[Docket No. 99-NM-361-AD; Amendment 39-11502; AD 2000-01-05]

Airworthiness Directives; Boeing Model 747 Series Airplanes

ACTION: Final rule; request for comments.

Lock Bar/Load Tool Installation and Gearbox Manual Lock Release
Figure 1

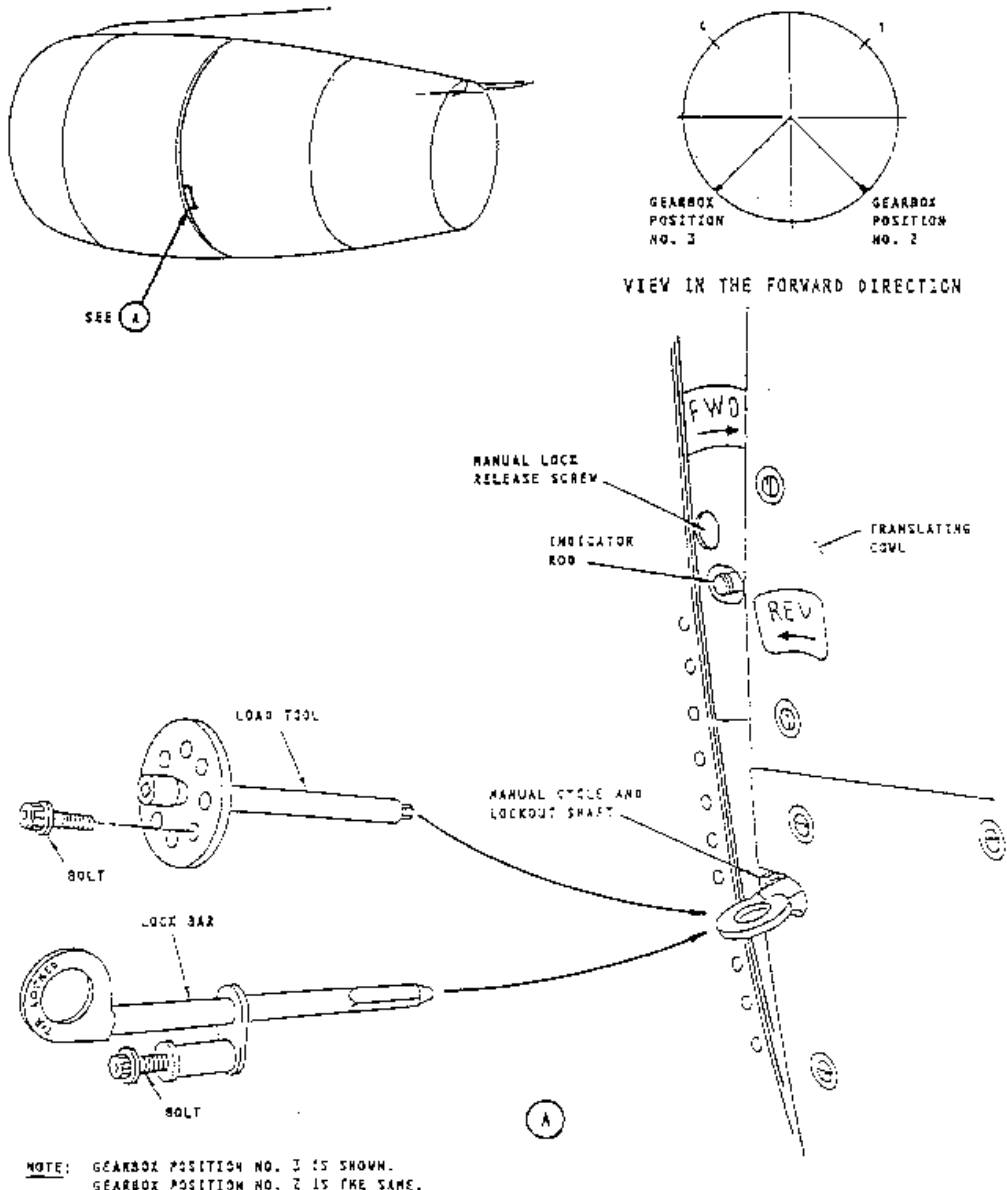
Accordingly, this action revises paragraphs (d) and (e) of that AD to remove all references to the AMM for accomplishment of the operational checks, and replace those references with references to Appendix 1 (including Figure 1) of this AD, which describes the Gearbox Lock and Air Motor Brake Test procedures required for accomplishment of the operational checks.

Repetitive operational checks to detect discrepancies of the gearbox locks and the air motor brake are required to be accomplished in accordance with the procedure included in Appendix 1 (including Figure 1) of this AD. Correction of any discrepancy detected is required to be accomplished in accordance with the procedures described in the Boeing 747 Airplane Maintenance Manual.

(d) Within 3,000 flight hours after accomplishing the modification required by paragraph (c) of this AD, or within 1,000 flight hours after September 15, 1999, whichever occurs later: Perform operational checks of the number 2 and number 3 gearbox locks and of the air motor brake, in accordance with the procedures described in Appendix 1 (including Figure 1) of this AD. Repeat the operational checks thereafter at intervals not to exceed 3,000 flight hours.

(e) If any operational check required by paragraph (d) of this AD cannot be successfully performed as specified in the procedures described in Appendix 1 (including Figure 1) of this AD, or, if any discrepancy is detected during any operational check, prior to further flight, repair in accordance with the procedures specified in the Boeing 747 Airplane Maintenance Manual. Additionally, prior to further flight, any failed operational check required by paragraph (d) of this AD must be repeated and successfully accomplished. Continue to repeat the operational checks thereafter at intervals not to exceed 3,000 flight hours.
